# **P28 Proposals**

### P28 Proposals by the Numbers

### **Urban Design Considerations**

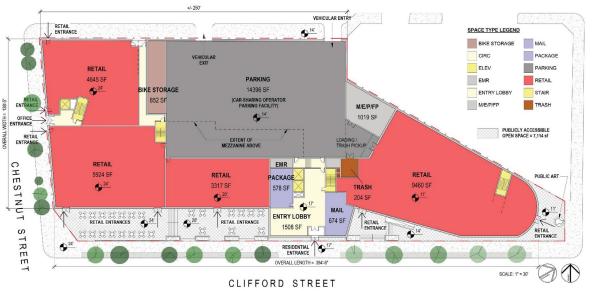
### Mostly positive urban design outcomes

- Pros:
  - Active ground floor uses along Clifford and Chestnut
  - Zero lot line along Chestnut and Friendship
  - Setback along CityWalk/Clifford Street frontage creates space for café seating and public art
  - Varying configuration of setback creates visual interest and negotiates between CityWalk setback and existing street wall
- Cons:
  - Two curb cuts and parking along most of Friendship Street façade

### **Building Program Considerations**

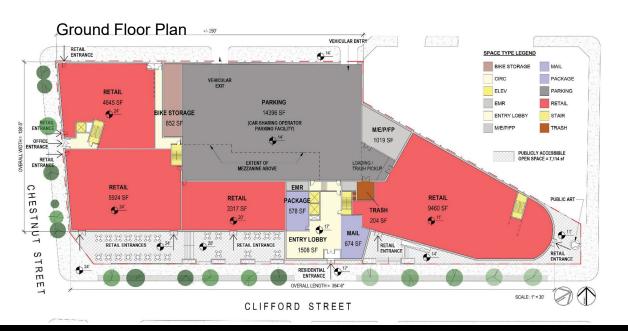
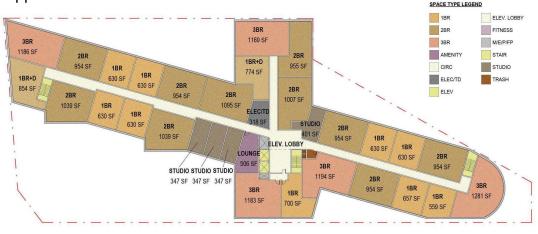
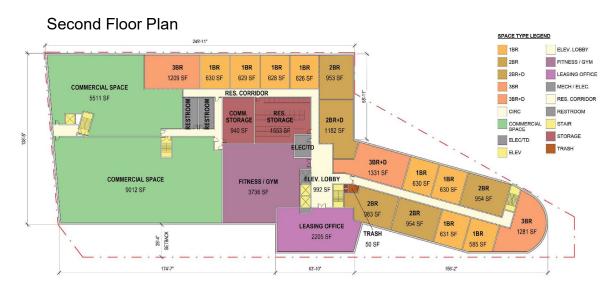
- Ground-floor retail and second-floor office require market justification
  - Volume of retail provided may exceed market demand, and the retail spaces are very large (3,317 9,460 SF)
  - Questionable viability of second-floor commercial space
- Inside corners created by the crossing of the two corridors creates tough-to-layout units with insufficient window wall frontage
- Proposal does not provide sufficient detail on how significant grade change will be accommodated

## Zoning

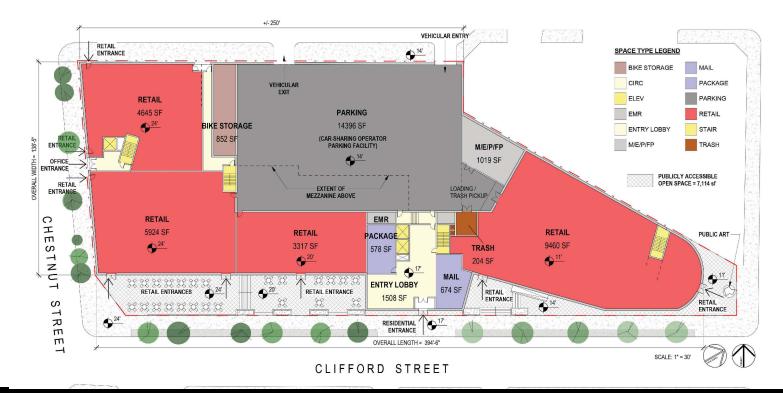
### Proposal requires height bonus and one waiver, which we would recommend for approval

- Proposal meets qualifications for 30% height bonus, because it includes:
  - Active uses >51% of ground floor area
  - Publicly accessible open space >10% of lot area
- Waiver required for setback along Clifford Street, however public open space and outdoor seating are approved uses for a setback, especially along pedestrian/bike networks (CityWalk)

### **Urban Design Considerations**

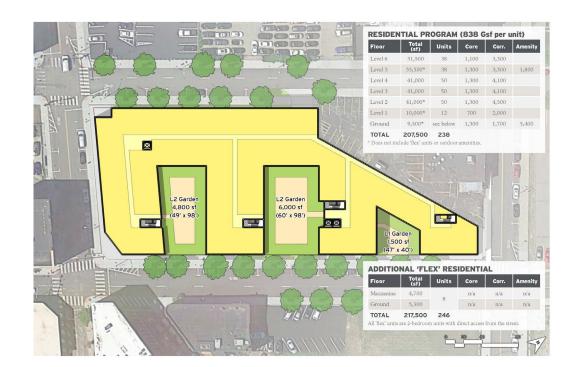
#### Positive urban design outcomes

- Zero lot line on all sides, with chamfered corners on Chestnut
- Active ground floor use along Clifford and Chestnut (CityWalk), although questionable market demand for amount of retail proposed
- Small/medium retail spaces with large anchor on Richmond and Clifford
- Individual entrances for "flex units" will break up Friendship Street façade
- Single curb cut and no blank garage wall

### **Architectural Considerations**

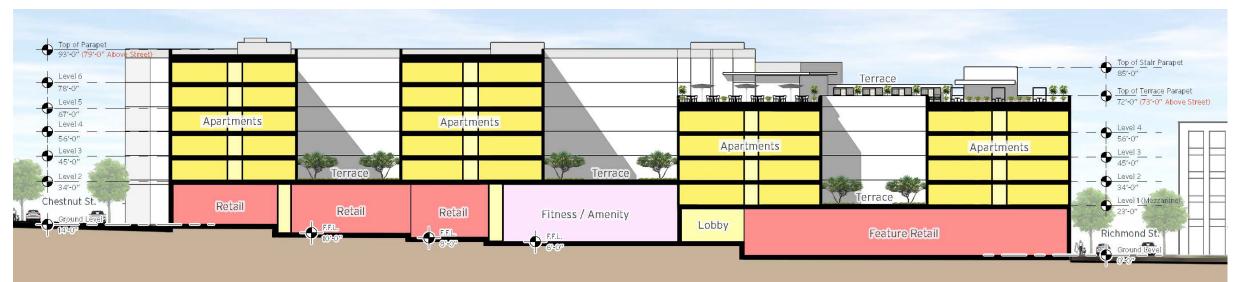
- Strategy for dealing with grade change is carefully worked out
- Abundance of inside corners will create challenging unit layouts

### **Urban Design Considerations**

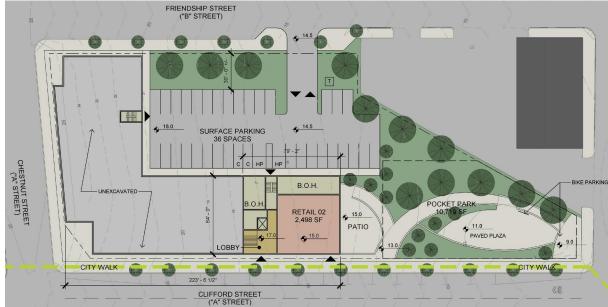
#### Proposal is suburban in character along several frontages, and does not maximize use of parcel

- Within build-to zone only on Chestnut and half of Clifford Street frontage
- Publicly accessible open space for half of CityWalk/Clifford Street frontage
- Surface parking visible along Friendship Street frontage (buffered by open space)

### **Urban Design Considerations**

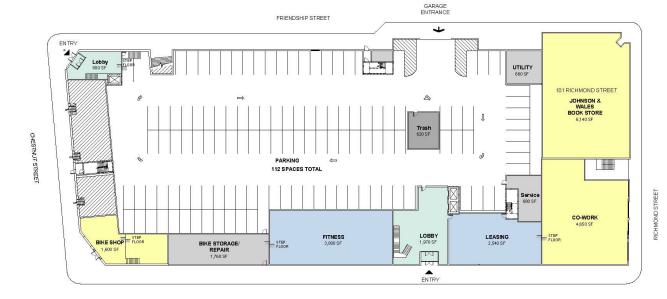
- Partnership with J&WU results in the redevelopment of existing vacant building, removal of surface parking, and full activation Richmond Street
- Pragmatic approach to parking and ground floor retail results in less-than-ideal activation of the other building edges
  - Pros:
    - Zero lot line on all sides
    - Townhouse units along Chestnut provide some activation and façade articulation despite being a private use
  - Cons:

- Most of frontage along CityWalk/Clifford Street consists of non-public uses
- Blank façade along almost entire Friendship Street frontage

Proposed Land Swap with Lot 555

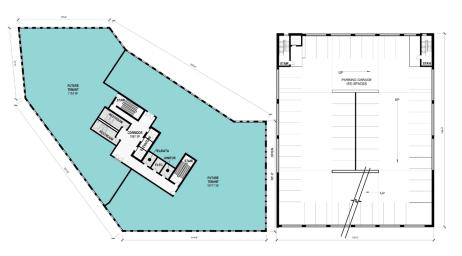
# Parking garage and ramp access have a negative impact on the quality of the public realm

- Garage is in very close proximity to Garrahy Garage
- J&WU land swap results in unknown outcomes at the corner of Clifford and Richmond, which is an important node for CityWalk
- Plaza activates corner of Chestnut and Clifford but retaining walls effectively make the space less public
- Expressed diagonal structure at the ground level is inconsistent with the desire to create human-scaled shopfronts

### **Building Program Considerations**

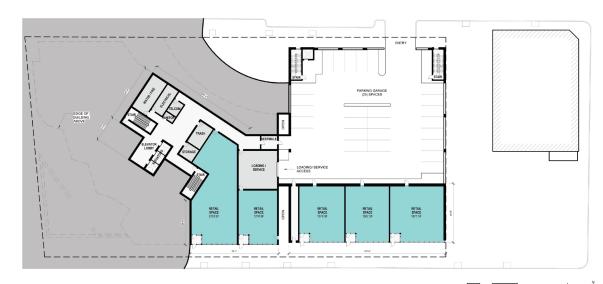
### Size and layout of office and retail require market justification

- Questionable viability of spec office
- Office floorplates are not optimized for the market in terms of both size and configuration
- Questionable demand for retail space (6 retail spaces at 1,300 2,700 SF plus one at 5,800 SF)
